Approval no: DEV2012/397

Development Element	Amendment application, most recently approved 27 April 2016	Permissible Change	Change
Plot Ratio	3.23	3.20	-0.03
Building Height	8 Storeys	8 Storeys	No Change
Total GFA	13,214m²	13,135m²	-79m²
Apartments	174	168	-6
Car Parking	178	169	-9 (due to loss of apartments)
Bicycle Parking	38	38	No Change

23-29 Abbotsford Rd Bowen Hills

PLANS AND DOCUMENTS referred to in the PDA **DEVELOPMENT APPROVAL**

SITE PLAN

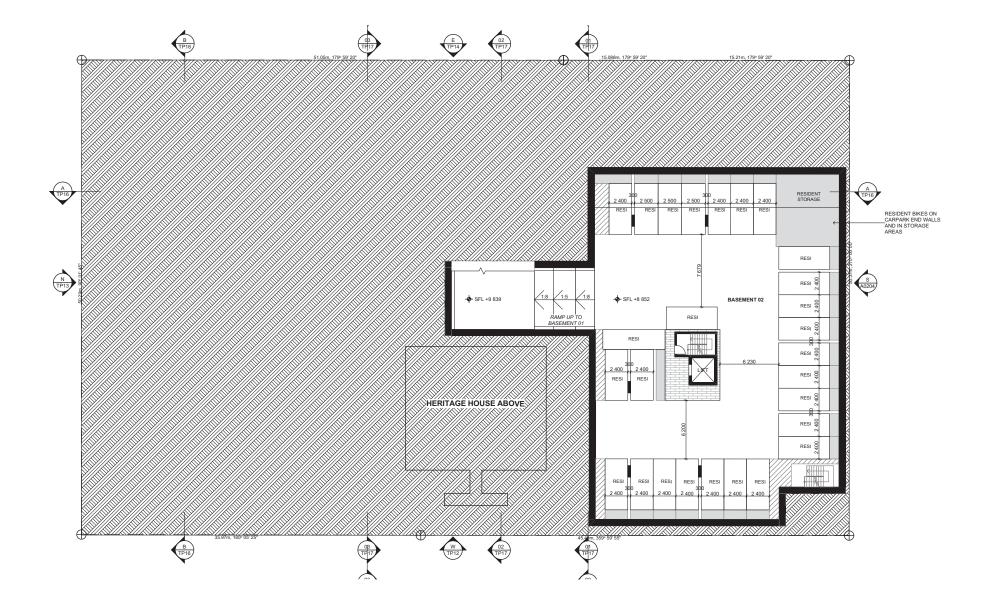
North Tower (Stage 1A) has been reconfigured to provide a more diverse mix of apartment offerings.

The basements have been split between the North and South Tower allowing for staged construction.

All services have been relocated to North Tower and will be constructed in Stage 1^A.

LEVEL 06-08 PLAN

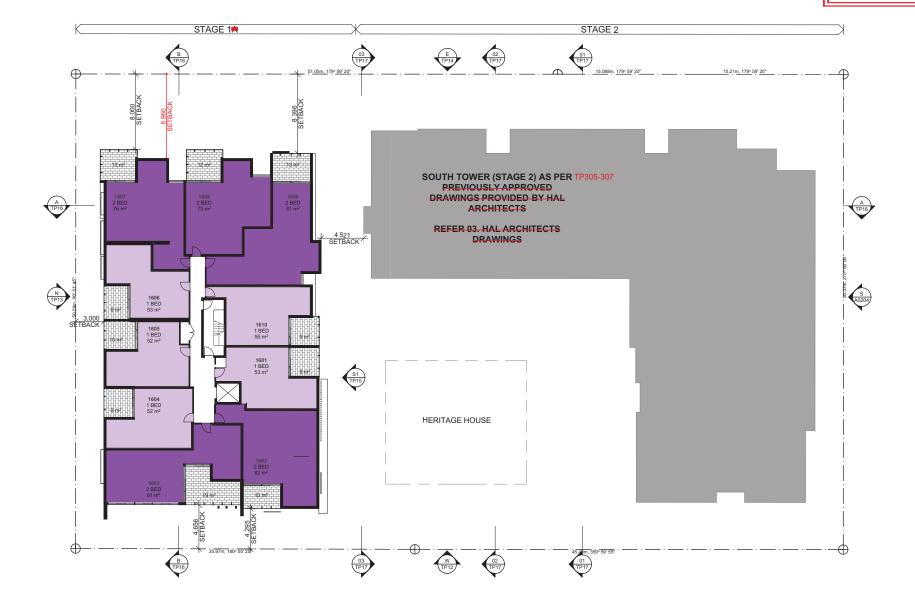
X SETBACK CONSITENT WITH ORIGINAL DA APPROVAL

01 HERITAGE HOUSE GROUND FLOOR PLAN
- SCALE: 1:100@A1

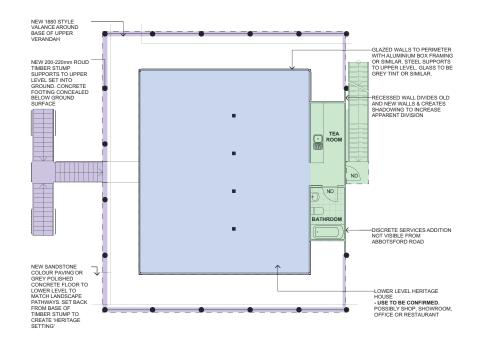
HERITAGE HOUSE -USE TO BE CONFIRMED.
